DEVELOPMENT DETERMINATION PANEL MEETING

ITEM 3.1	REV2020/0023 - 205 RIVERVIEW ROAD, AVALON BEACH - REVIEW OF DETERMINATION OF APPLICATION DA2019/1069 FOR ALTERATIONS AND ADDITIONS TO A DWELLING HOUSE INCLUDING A SWIMMING POOL
REPORTING MANAGER	Steve Findlay
TRIM FILE REF	2020/565310
ATTACHMENTS	1 Assessment Report 2 Site Plan & Elevations

REVIEW OF DETERMINATION ASSESSMENT REPORT

Application Number:	REV2020/0023
Responsible Officer:	Anne-Marie Young
Land to be developed (Address):	Lot 4 DP 18667, 205 Riverview Road AVALON BEACH NSW 2107
Proposed Development:	Review of Determination of Application DA2019/1069 for alterations and additions to a dwelling house including a swimming pool
Zoning:	E4 Environmental Living
Development Permissible:	Yes
Existing Use Rights:	No
Consent Authority:	Northern Beaches Council
Delegation Level:	DDP
Land and Environment Court Action:	Yes
Owner:	Kristen Rooney
Applicant:	Kristen Rooney
Application Lodged:	15/07/2020
Integrated Development:	No
Designated Development:	No
State Reporting Category:	Refer to Development Application
Notified:	22/07/2020 to 05/08/2020
Advertised:	Not Advertised
Submissions Received:	4
Clause 4.6 Variation:	Nil
Recommendat

Figure 1 : Building height non-compliance with 8.5m shown in pink

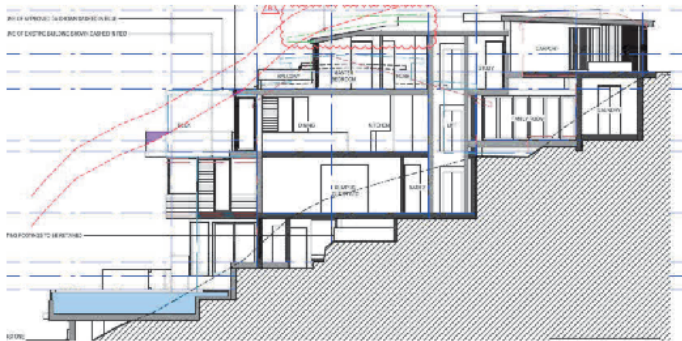
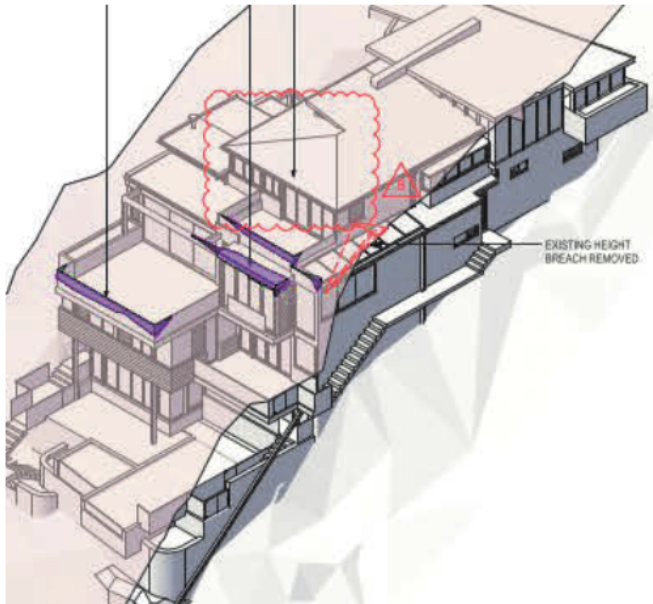
Building Height was not listed as a reason for refusal in the determination of the original DA. Despite this, an assessment of building height is provided below:

The building height non-compliance with the 8.5m height is demonstrated in the images below.

Figure 2 : Building height non-compliance with 8.5m shown in pink. (Note: the deck to the master-bed room is no longer non-compliant)

While the proposal includes an additional floor, the non-complying elements relate to the amendments to the existing three levels that are proposed to be reconfigured with internal changes, new access and balcony elements and a new roof form. The changes recommended by the Panel do not result in a change to the building height which has been assessed as acceptable.

Figure 3. Extent of excavation shown red

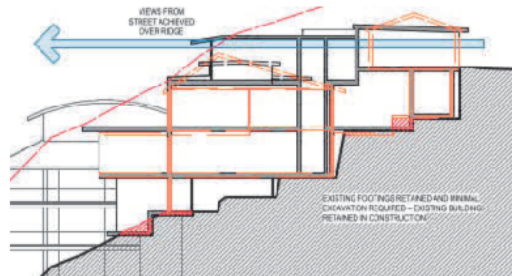
The proposal is reliant upon a minor volume of excavation under the footprint of the carport on the Ground Floor Level and under the footprint of the Lower Ground Floor Level for the proposed toilet and bathroom for the Pool Level as shown in figure 3. However, the visual impact of the minor excavation will be screened from view, and the proposal presents as a dwelling that has been sited to sympathetically follow the natural slope of the land.

The proposals design with the open style rear balcony areas, provides a more "stepped" look when viewed from the rear and the neighbouring properties. The proposal reflects the established built form character of the immediate Riverview Road area where multi-level, variably stepped houses are prevalent, due to the steep topography of the land and difficulty with pedestrian and vehicular access.

East elevation of proposed carport showing refined transparent screen and lower boundary wall to street

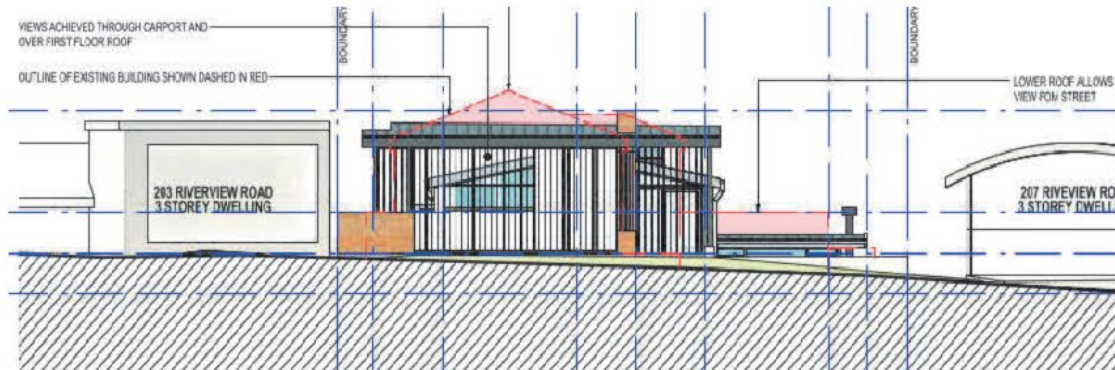
The revised proposal addresses the Panels concerns with a transparent screen to the front and either side of the carport to minimise the visual impact of the structure when viewed from Riverview Road and allow improved partial views to the Pittwater Waterway from the public street. The design of the carport reduces the built form of the existing car port. The pitched tiled roof profile is reduced with a lower height flat roof profile and the brick walls, balustrades and piers are replaced with lightweight steel posts which have been spaced to allow improved views to the Waterway from the public domain, refer to images below.

East elevation of the original (refused) proposal under DA2019/1069

Proposed sunlight to deck at 12.00 noon
(Neutral impact to existing development)

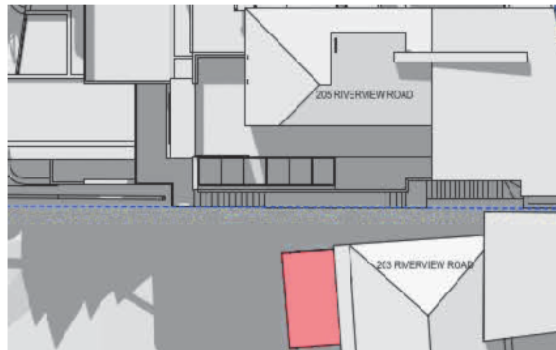
Proposed 9.00am shadow, the deck is in shadow.
(Note: there is no change to the shadow impact in the DDP recommended scheme)

Existing sunlight to deck at 12.00 noon

**Proposed sunlight to deck with DDP scheme at 12 noon
(Slight improvement to the existing situation and the proposed
scheme, namely a 5.4sqm (10.7%) increase in proposed and existing solar access)**

There is no change to solar access to the POS in question at 3.00pm between the subject scheme and the envelope suggested by DDP.

The main private open space affected by the development is the west facing deck located on the middle level of No. 203 Riverview Road. The existing building overshadows the northern elevation of the deck which currently has a privacy screen attached to its northern edge. However, it should be noted that this deck receives full sunlight between 12.00 noon and 3.00pm, complying with the control, refer to the plan shadow diagrams above.

Living room window

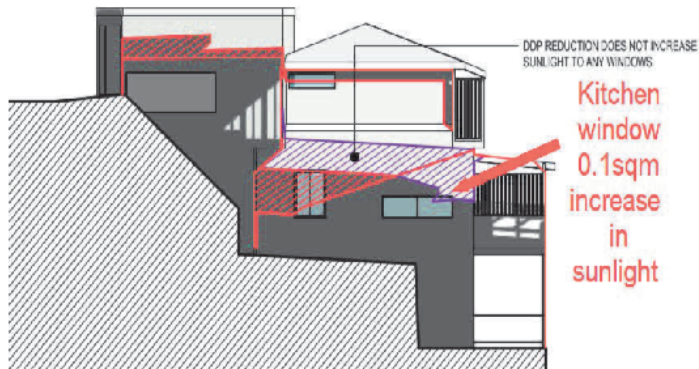
In terms of the windows that will be affected by the proposal these relate to a highlight living room window on Level 3, and bedroom window and kitchen window on Level 2 located on the northern elevation. An assessment of solar access to each window is provided below.

The principal living area affected by the development is the living room on the upper level. The only window affected is a high level window on the northern elevation which is partially shaded by the eaves of its own roof. The existing building at 205 Riverview Road overshadows this window at 9.00am and 10.00am, and is unaffected by the existing building from 11am to 3pm. The proposed development results in additional overshadowing of this window only at 11am, and is unaffected by the proposed development from 12 noon to 3.00pm. This fully complies with the control. The changes requested by the DDP do not result in any increase in sunlight to this living room window. Refer to image below.

Level 1 plan - New section of stair highlighted in blue

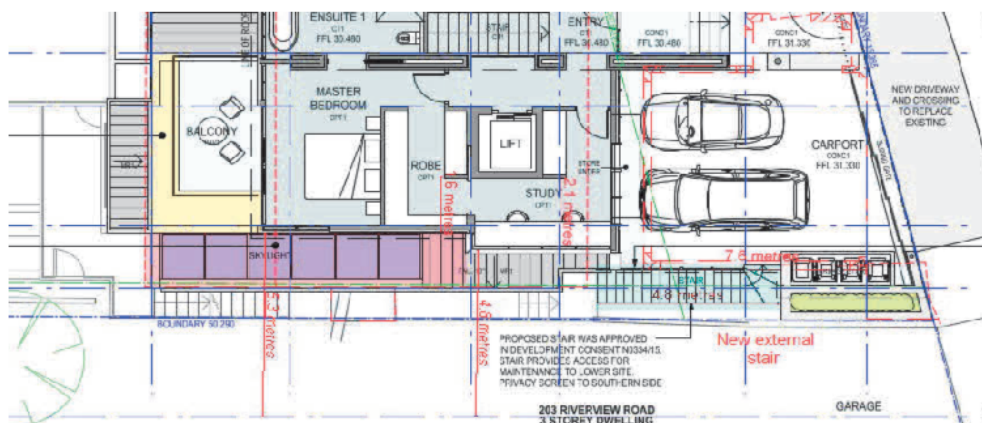
The proposal has been amended to include a 1.6m high privacy screen to the new section of external stair will ensure that privacy is maintained to the bedroom window in the northern elevation of No. 203 Riverview Road. In addition, it is noted that the section of new stair provides a secondary transitional connection between carport at ground level and the existing service stair which provides access to lower external levels of the subject site. The principle pedestrian access is located on the northern side of the dwelling. As such, it is not anticipated that the use of this stair will give rise to excessive use or visual or acoustic amenity impacts to the southern neighbour.

The privacy impacts to the new section of stair have been assessed as **neutral impact** given the existing arrangement, the addition of the privacy screen and the fact that this is a secondary service stair. A site visit has also confirmed that the southern boundary has extensive vegetation which provides a soft screen between the stair and the neighbouring property. In addition, the existing service stair has a 1.6m privacy screen attached to the southern edge. The applicant in justifying the stair notes that the structure was approved under N0334/15. A search of Council records confirm that this is correct.

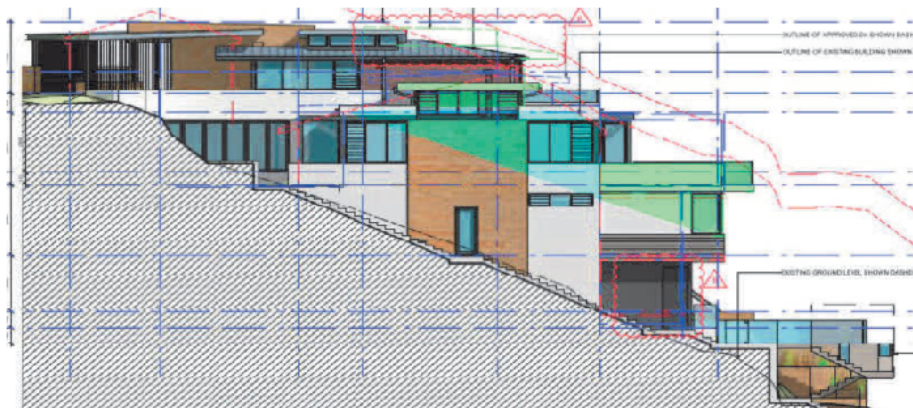
The proposed development has substantial breaches of the building envelope, particularly at the uppermost level which results in impacts upon views from the street and a scale of the development as viewed from the waterway and neighbouring properties which is inconsistent with the desired future character of the area.

It is also note that in order to address this issue and other issues that the Panel suggested

increasing the setback of the top floor between 2.5m - 2.0m from the southern boundary. Below is an assessment of the building envelope breach against the objective of the envelope provision, taking into consideration the issues recorded by DDP. The applicant has confirmed that it is not feasible to reduce the internal floor area and it is argued that the proposal as submitted without the reduced envelope addresses the provisions of the relevant controls, including clause D1.11 (side envelope).

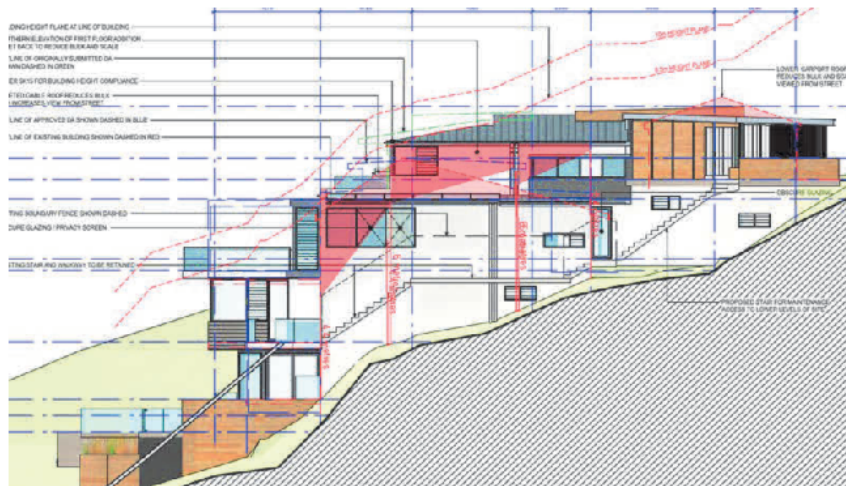
The proposal results in the following additional envelope breach to the northern elevation:

Two additional areas measuring up to 3.3m in height and 5.5m in length and 1.6m in height and 4.4m in length. It is noted that the DDP did not raise any specific issues with the breach to the northern elevation.
